Subject: Webform submission from: Bays West Stage 1 Rezoning Proposal

The following issues have been identified for further consideration by the Department of Planning and Environment for the Bays West Precinct Stage 1:

Inner West Council appreciates the opportunity to comment on the exhibited draft Bays West Stage I Comprehensive Rezoning Package - White Bay Power Station and Metro subprecinct.

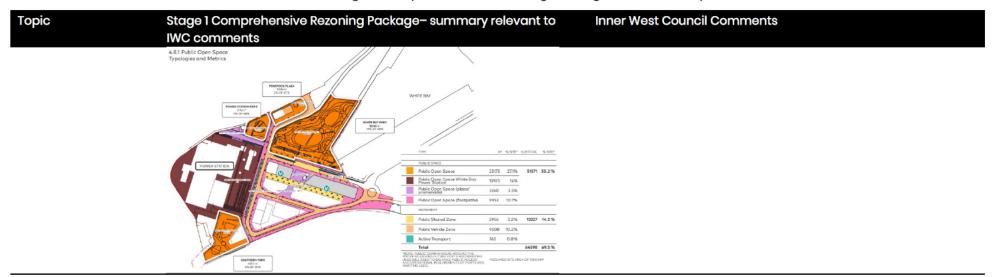
As map 4.8.1 of the draft masterp an shows, the current a owance of 55.2% pub ic open space will ensure the precinct is wide y accessible to a demographics within Sydney. However, council does not agree that this number is truly representative of what is being provided on site. 10% of the 55.2% public open space is footpath circulation space. Council does not agree that this constitutes public open space, and request that it should be transferred to the movement table. This lowers the 55.2% to 44.5% public open space. This is only barely acceptable, and Council would support a solution that gets the public open space over 50%.
